From: Danny Aleshire <danny.aleshire@awattorneys.com>
Sent time: 08/28/2018 12:07:44 PM
To: Galvez, Karla@Coastal <Karla.Galvez@coastal.ca.gov>; Selim <Selim@sawayaeng.com>; Ara Mihanian
Rehm, Zach@Coastal <Zach.Rehm@coastal.ca.gov>; Sexton, Pat@Coastal <Pat.Sexton@coastal.ca.gov>; Hudson,
Cc: Steve@Coastal <Steve.Hudson@coastal.ca.gov>; Jill Martin <jmartin@trumpnational.com>; Posner, Chuck@Coastal
<Chuck.Posner@coastal.ca.gov>
Subject: RE: Tract 50666 # Final Map
Attachments: City Owned Parcels and Trails.pdf

Comments to Revised Tract Map 50666

CALIFORNIA COASTAL COMMISSION
TRUMP NATIONAL GOLF CLUB
CITY OWNED PARCELS
CITY OWNED PUBLIC TRAIL EASEMENTS
TRACT 50666 AND TRACT 50667

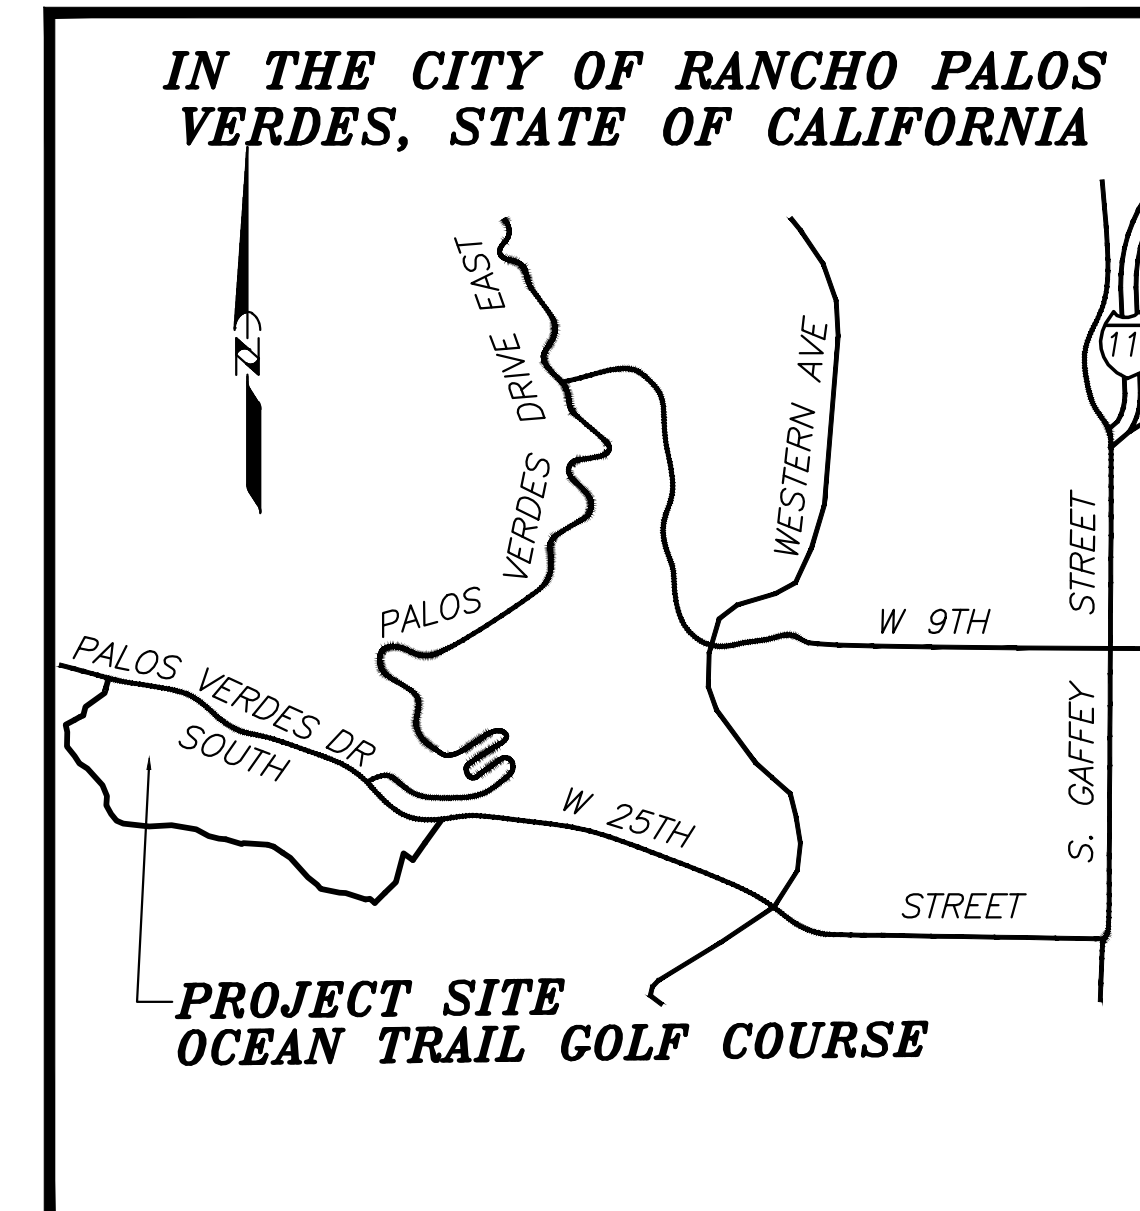
See attached for the Map Selim prepared showing the lots and trails to be dedicated to the City (except it mistakenly shows Lot A as being retained by the HOA). The legend below shows that the Ocean Vista Bikeway and Trail are either already owned by the City or will be owned by the City.
